PACKAGING

*In this installation there are 3 or 4 critical points to evaluate:

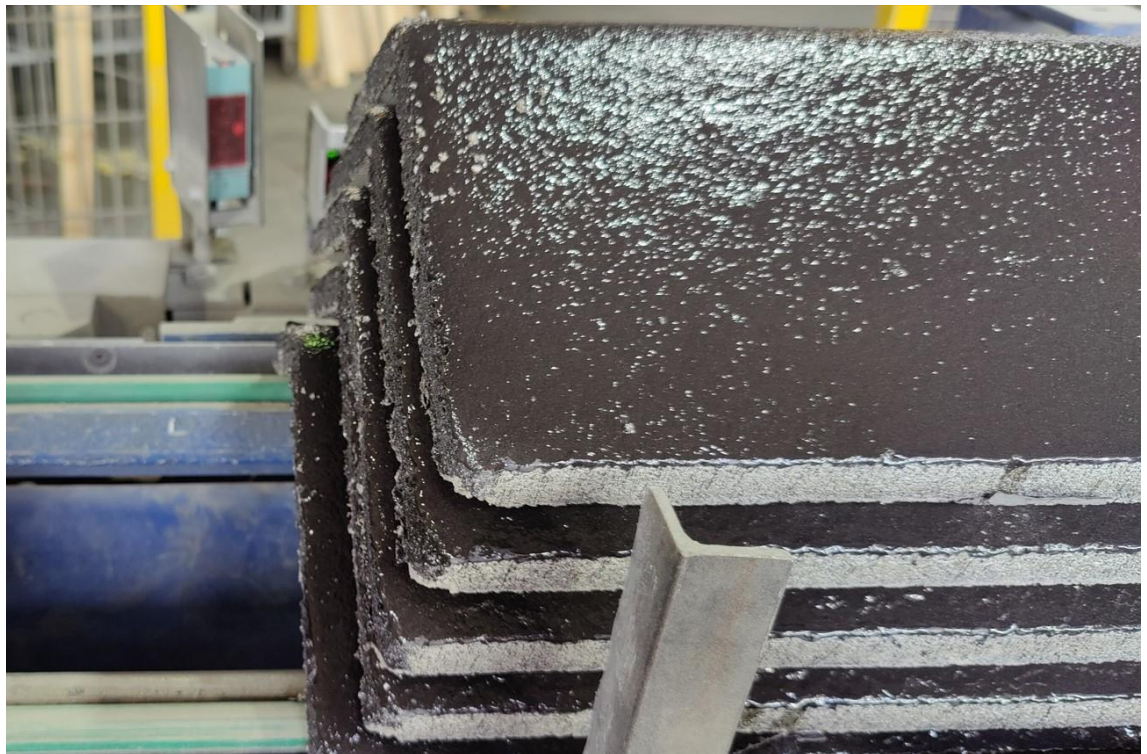
1) Forming packages of 4 tiles, the tiles are not well aligned.

(They should be aligned as the bundle is being formed or when strapping).

***See the possibility of aligning the tiles in the formation of the package.**

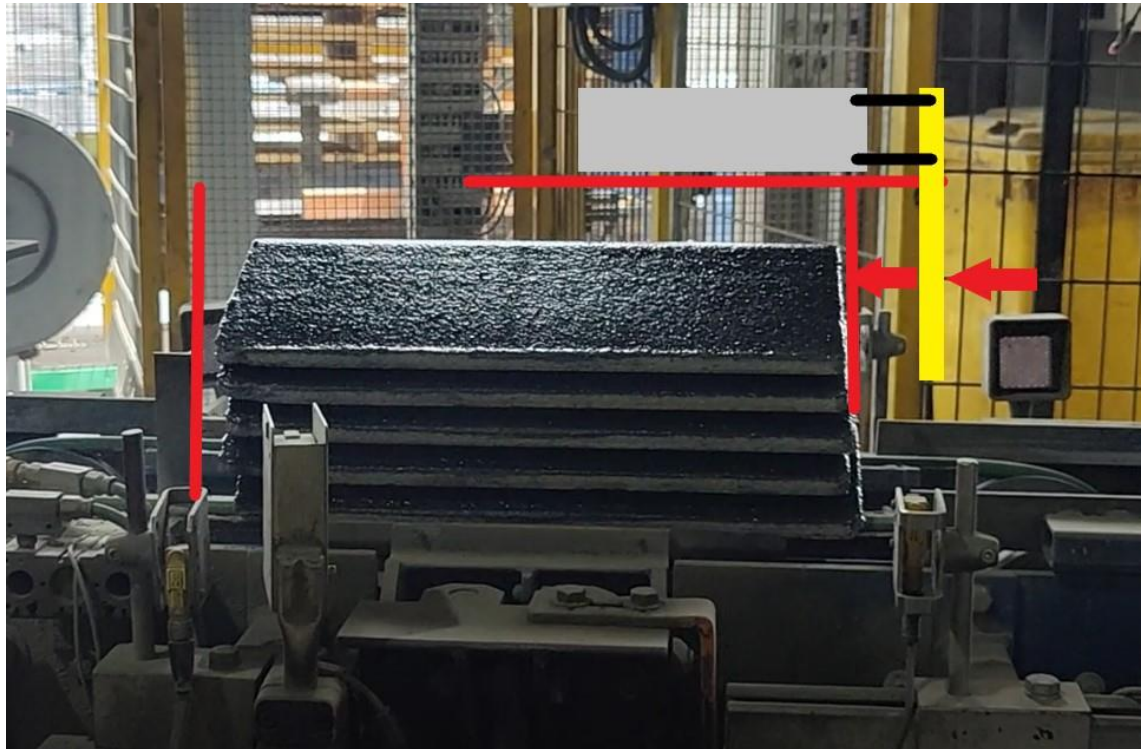
2)*When strapping the packages of 4 tiles, they do not fit well, the strap seems to me too rigid and does not fit, for the arch of the 4 tiles,

(Poorly fitted and poorly welded/not aligned).

***See the possibility of aligning the tiles in the strapping of the package.**
